System Characterization Work Plan Part 1 (QAPP)
System Characterization Work Plan Part 2 (QAPP)
and
NJDEP approval letters dated October 20, 2016

Re: Receipt of Amended Sewer System Characterization Work Plan Part 1
PVSC, NJPDES Permit No. NJ0021016
Paterson City, NJPDES Permit No. NJ0108880
Newark City, NJPDES Permit No. NJ0108758
Kearny Town, NJPDES Permit No. NJ0111244
Harrison Town, NJPDES Permit No. NJ0108871
East Newark Borough, NJPDES Permit No. NJ0117846

**SYSTEM CHARACTERIZATION AND
LANDSIDE MODELING PROGRAM
QUALITY ASSURANCE PROJECT PLAN (QAPP)
PART 1**

Re: Technical Comments on the Sewer System Characterization Work Plan Part 1
Borough of East Newark, NJPDES Permit No. NJ0117846
Town of Harrison, NJPDES Permit No. NJ0108871
Town of Kearny, NJPDES Permit No. NJ0111244
City of Newark, NJPDES Permit No. NJ0108758
City of Paterson, NJPDES Permit No. NJ0108880
PVSC, NJPDES Permit No. NJ0021016

Figure 1 – PVSC Sewer District

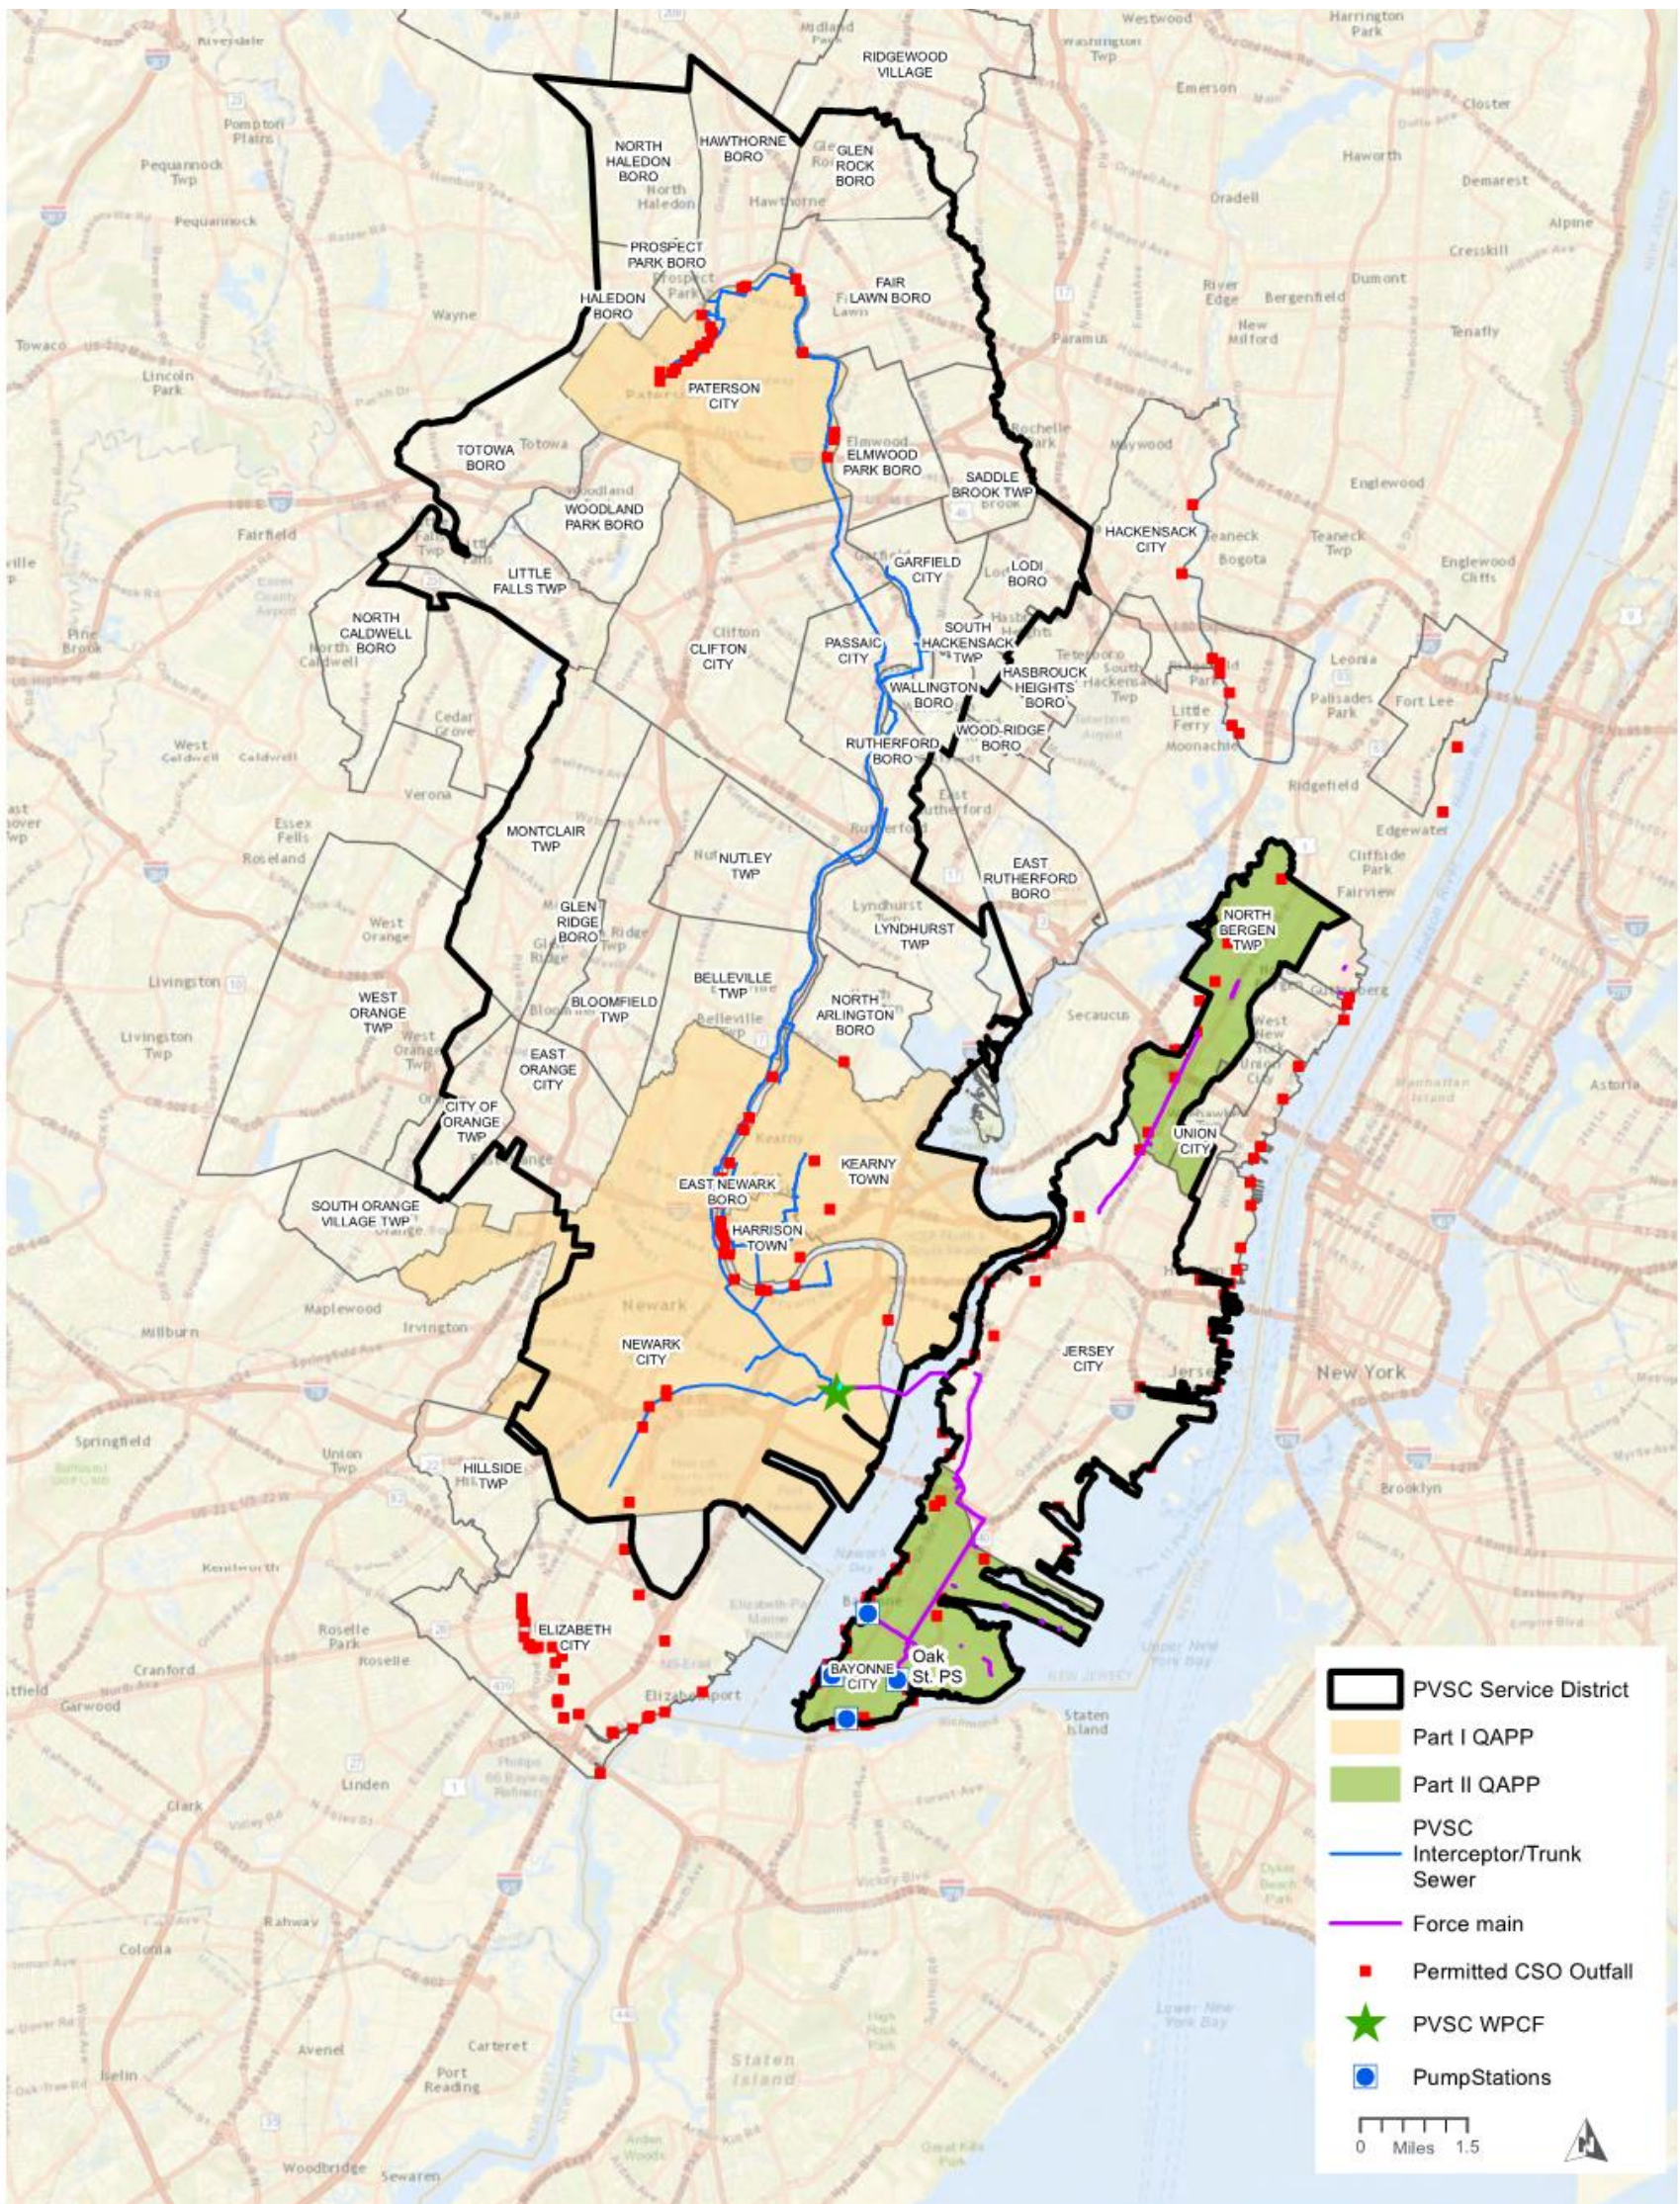
Comment 18: Figure 1 is included on page 14. While force mains are included in the legend, it appears that neither the force mains jointly owned by Bayonne MUA and Jersey City MUA nor the Hudson County force main is shown. Please revise the figure accordingly.
